CITY OF PORTSMOUTH, NH

MADBURY WTP UPGRADE AND
BELLAMY RESERVOIR IMPROVEMENTS

RESPONSE TO BIDDERS QUESTIONS

ADDENDUM NO. 2

Item 2-30. Drawing S-30

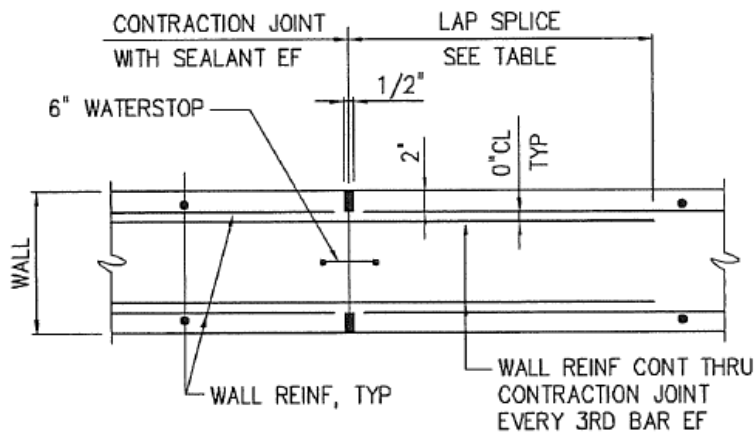
A. Delete following text: "Xref L:\SDetails\0331713.dwg" and replace with the detail below:

Item 2-39. Drawing I-10

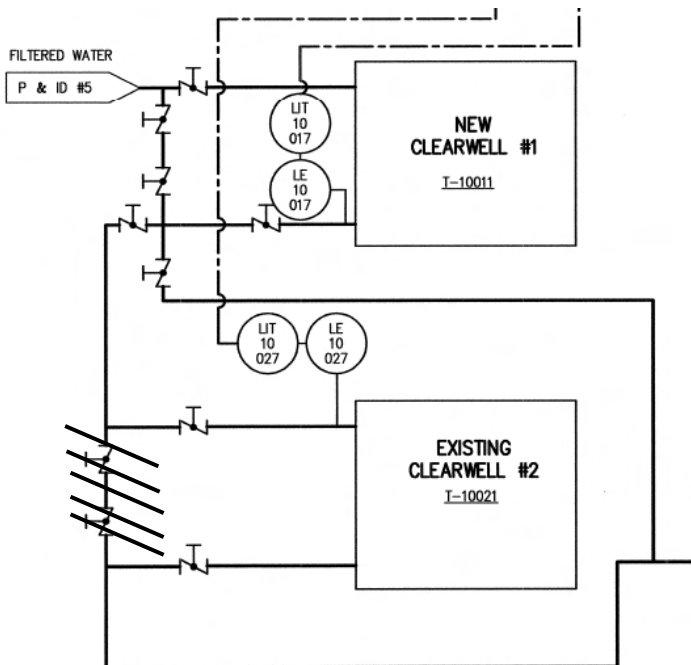
- 2-4. Drawings C-11 and I-10 do not match with regard to the finished water valving at the entrance to Existing Clearwell #2. There is not an interconnection on Drawing C-11 that coincides with the two valves (in the vertical) shown just left of the “Clearwell #2” box shown on Drawing I-10.

- A. Delete the two butterfly valves and associated piping as shown in the figure below.

The valves are correct as shown on Drawing C-11; the interconnection shown on Drawing I-10 has been deleted from the design. See Addendum 2 Item 2-39.

FLOATED SOLIDS PUMPS ENLARGED PLAN

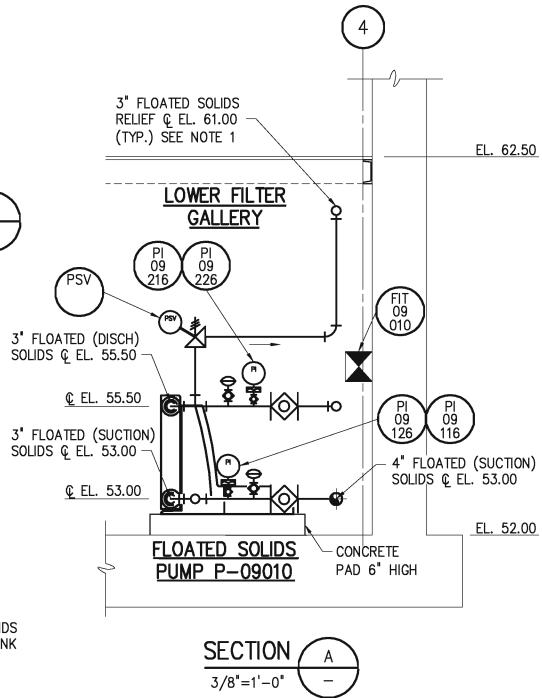
- 2-79. Please clarify the relief valve piping for the Floated Solids Pump discharge as shown on drawing I-11 and not on drawing M-2.

- A. Delete Detail 1 in its entirety and replace with Detail 1 in attached Sketch M2-SK-01.

NOTE:
 1. 3" FLOATED SOLIDS RELIEF HEADER @ EL. 61.00 SHALL TERMINATE AT THE INSIDE FACE OF THE FLOATED SOLIDS TRANSFER TANK USING TYPE "A" WALL PENETRATION.
